V2500-A5/D5 PROPULSION SYSTEMS NON-MODIFICATION SERVICE BULLETIN

This document transmits Revision 2 to Service Bulletin EV2500-72-0427

V2500-ENG-72-0427

NON MODIFICATION SERVICE BULLETIN – ENGINE – NO. 5 SCAVENGE TUBE LOT NUMBER M268050S1
IDENTIFICATION AND REPLACEMENT OF

Remove the No.5 Bearing Scavenge Tube
Figure 1

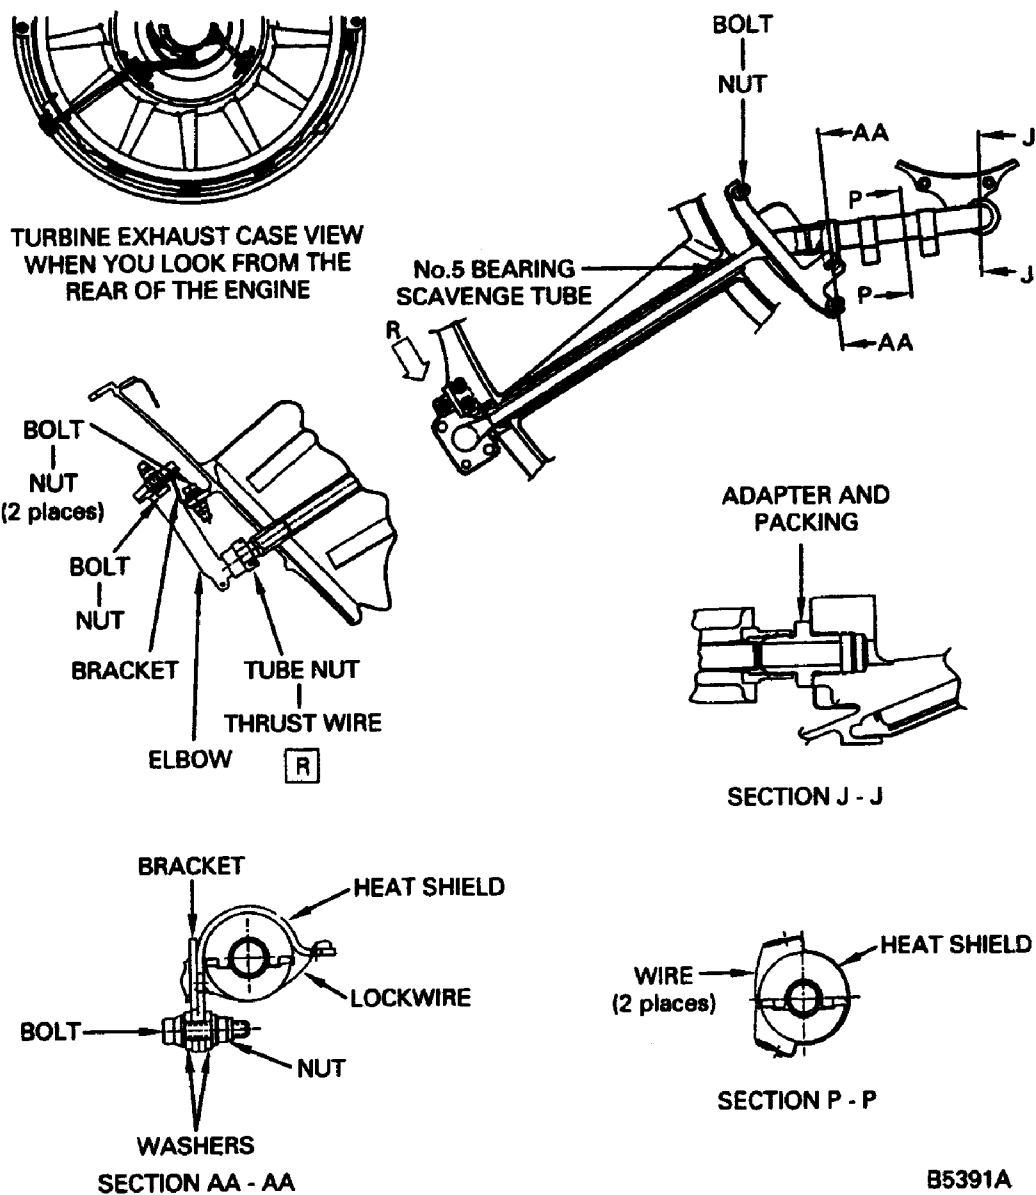
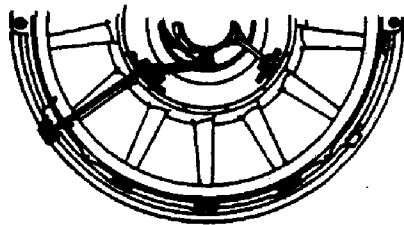
- (b) Disassembly instructions: Remove the No.5 Bearing Scavenge Tube. Reference EM 72-50-50-040-001 and Figure 1.

- (i) Remove the bolts and nuts that attach the bracket to the oil scavenge tube and to the rear external flange of the turbine exhaust case. Remove the bracket.
- (ii) Disconnect the scavenge tube nut at the elbow at external opening incase. Remove the elbow.
- (iii) Remove the thrust wire from the tube nut at the external opening in the case. Remove the tube nut and discard the thrust wire.
- (iv) Release the nut that attaches the oil scavenge tube and the heat shields to the inner bracket. Remove the nut, washers and bolt.
- (v) Remove the lockwire that attaches the two heat shields to the scavenge tube and remove the two heat shields.

- (vi) Remove the two bolts and nuts that attach the inner bracket to the inner support of the turbine exhaust case. Remove the bracket. Release the tube nut from the inner adapter on the exhaust case. Remove the adapter from the inner support of the turbine exhaust case.

Install the No.5 Bearing Scavenge Tube
Figure 2

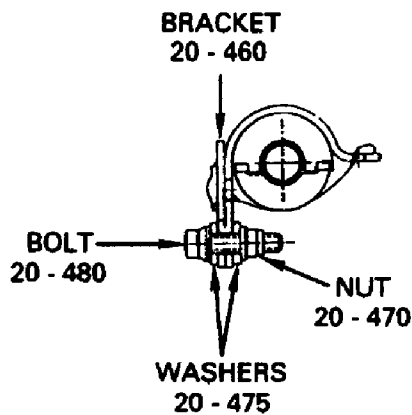
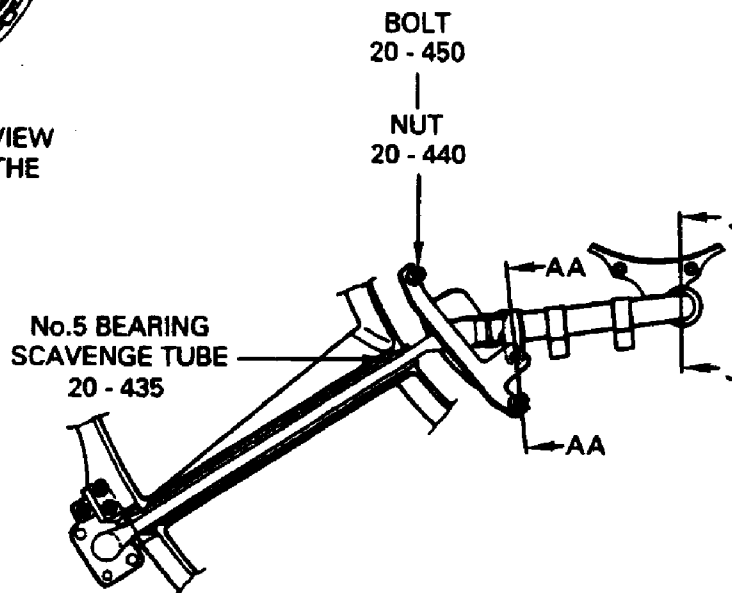
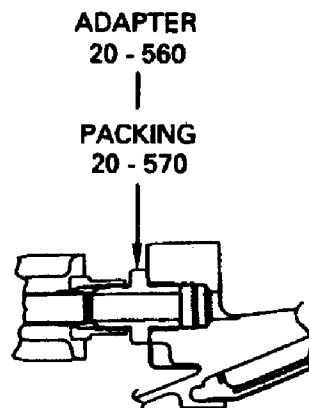
- (vii) Discard the packing.
- (c) Assembly instructions: Install the No.5 Bearing Scavenge Tube. Reference EM 72-50-50-040-060 and Figure 2.
 - (i) Install a new Packing PN AS3209-015 (1 off) on the Adapter PN 50P186. Install the adapter and packing to the scavenge port on the Exhaust Case housing. Torque the adapter 150 to 170 lbfin (16,948 to 19,207 Nm).

- (ii) Install the No.5 Bearing Scavenge Tube PN 2A3092-01 into the exhaust case strut and attach the tube nut to the adapter, hand tight only. Assure that the replacement tube does not have lot number MS26050S1 on nut as referenced in A3.

- (iii) Attach the Tube Nut PN 493975 to the Scavenge Tube with ThrustWire PN ST1003-07 where the tube comes out of case.
 - (iv) Install the Bracket PN 2A2212 (if removed) and secure with two Bolts PN 4W0002 and Nuts PN 4W0165 hand tight only to the external flange of the case.

- (1) Torque the inner tube nut 225 to 250 lbfin (25,422 to 28,246 Nm). Lockwire the tube nut and adapter.
- (2) Torque the outer tube nut 320 to 350 lbfin (36,155 to 39,545 Nm). Lockwire the tube nut, thrust wire and elbow.
- (3) Torque the three nuts which hold the elbow to the bracket and the bracket to the case 85 to 95 lbfin (9,604 to 10,734 Nm).
- (vi) Install the Bracket PN 2A2176 onto the inner support of the case. Install the two Bolts PN 4W0165 and the two Nuts PN 4W0002. Torque the nuts 85 to 95 lbfin (9,604 to 10,734 Nm).
- (vii) Install the upper Heatshield and Lower Heatshield (previously removed assembly PN 2A2242) over the inner end of the Scavenge Tube.

(viii) Install the Bolt (72-50-53,20-480), washers (72-50-53,20-475) and nut (72-50-53,20-470) to secure the upper heatshield to the bracket on the inner housing. Torque the nut 36 to 40 lbfin (4,067 to 4,519 Nm).
